MONTICELLO NUCLEAR GENERATING PLANT

REQUEST FOR AMENDMENT TO
OPERATING LICENSE NO. DPR-22

(License Amendment Request Dated March 11, 1976)

LICENSE AMENDMENT REQUEST DATED MARCH 11, 1976

Figure 2. Group 2 Isolation Logic for Outboard Isolation Valves.

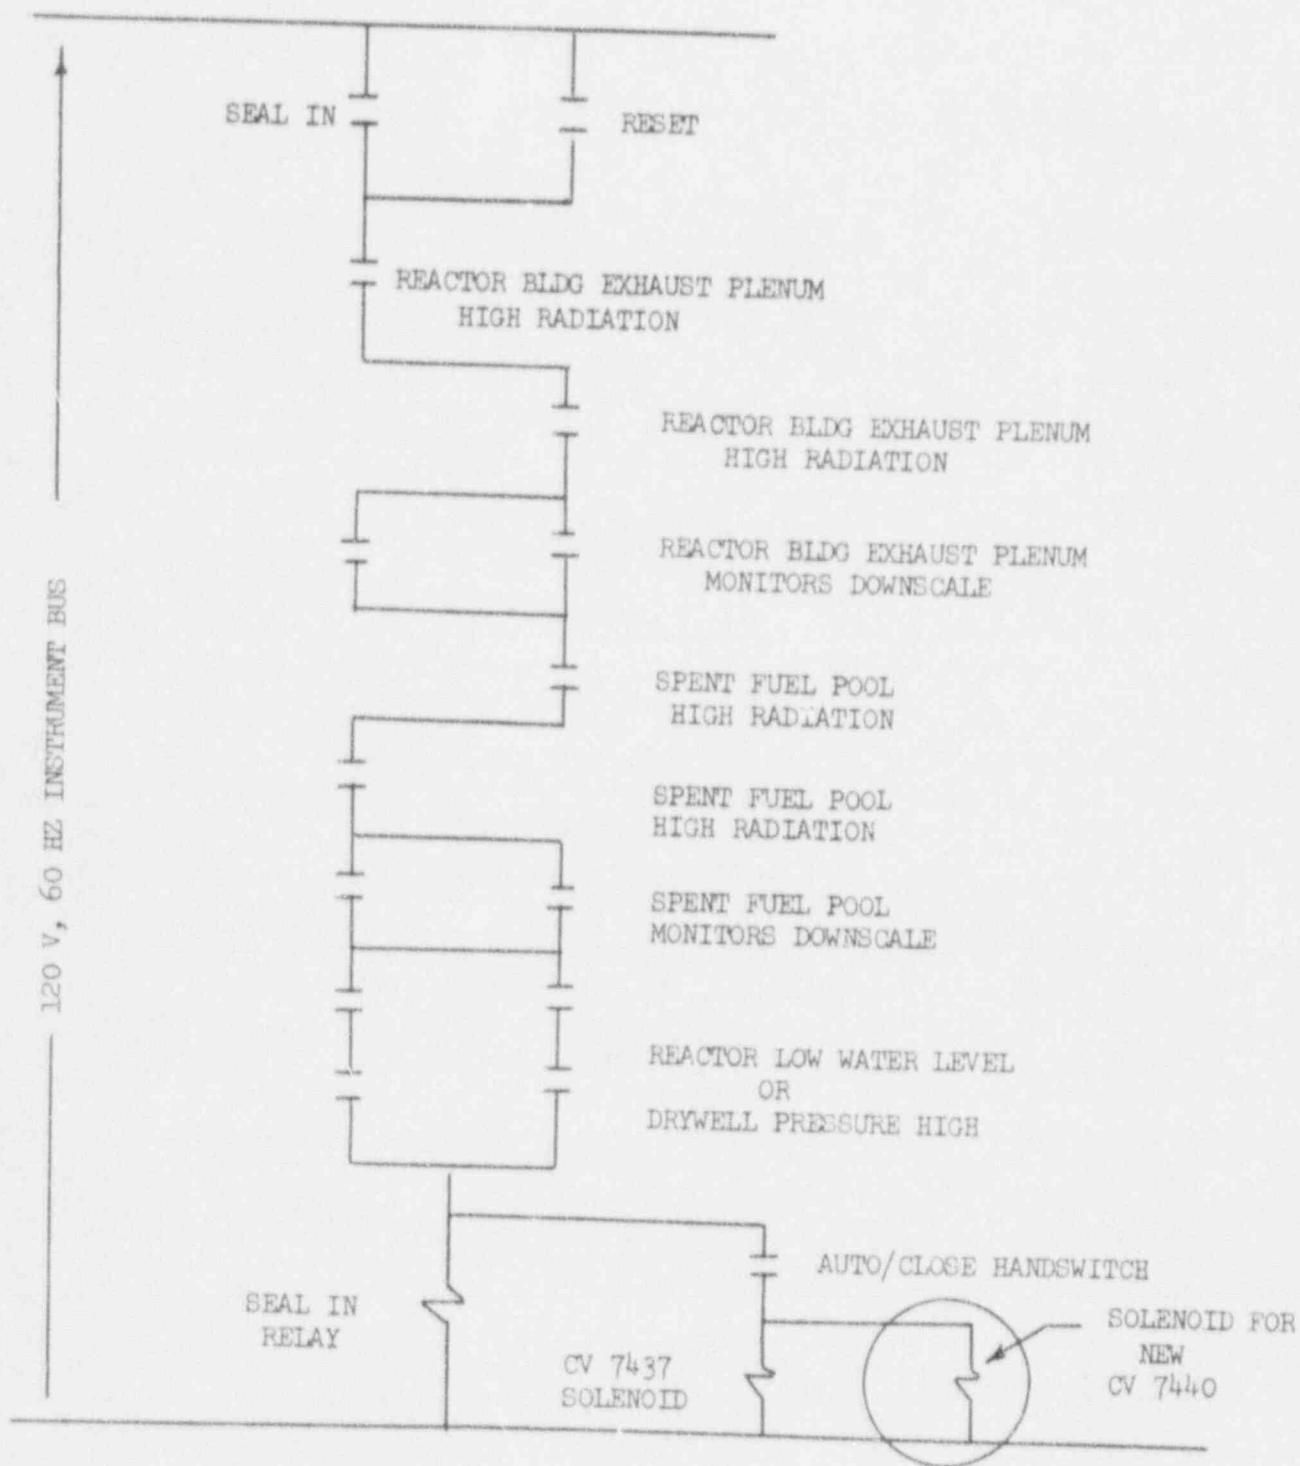
Since the isolation logic for the outboard isolation valves is separate from the inboard valves, the necessary separation criteria required for isolation valves in series is satisfied (Figure 2).

CV-7440 will be provided with limit switches which indicate if the valve is open or closed. These limit switches will be wired in conjunction with the limit switches of CV-7437 so that both valves must be closed to get the proper indication in the control room. The handswitch for CV-7437 will also control CV-7440.
